Item Name: Replacement Skidtube, High Gear with Standard Wearplates Fits LH or RH

DRAWING NO. D2650	TITLE 206/407 SKIDTUBE ASSEMBLIES	REV. F	DART AEROSPACE LTD ENGINEERING ORDER		D.E.O. NO. D2650-F-1	SHEET NO. SHEET 1 OF 1	SCALE NTS
DRAWN <i>[Signature]</i>	CHECKED <i>A.P.</i>	MFG. APPR. <i>[Signature]</i>	APPROVED <i>[Signature]</i>		DE APPR. <i>[Signature]</i>		
DATE 12.10.12	DATE 12.10.22	DATE 12.10.22	DATE 12.10.22		DATE 12.10.22

CHANGE C'BORED WELDED CROSSBOLT SPACERS TO SWAGED SPACERS

DETAIL G

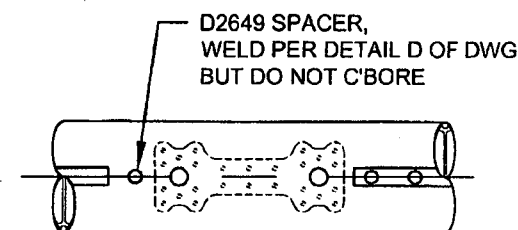
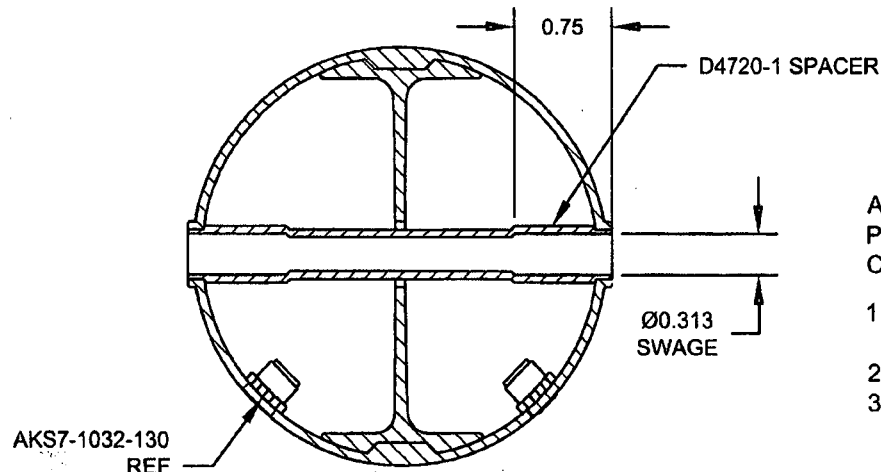
ADD DETAIL G BELOW, WHICH IS THE SAME SECTION VIEW AS DETAIL D OF DWG.
C'BORED HOLES ARE **NOW SWAGED** PER DETAIL G BELOW. FOR THE Ø0.375 HOLE THAT IS NOT C'BORED, WELD PER DETAIL D OF DWG (SEE AMENDED DETAIL B FOR REFERENCE).
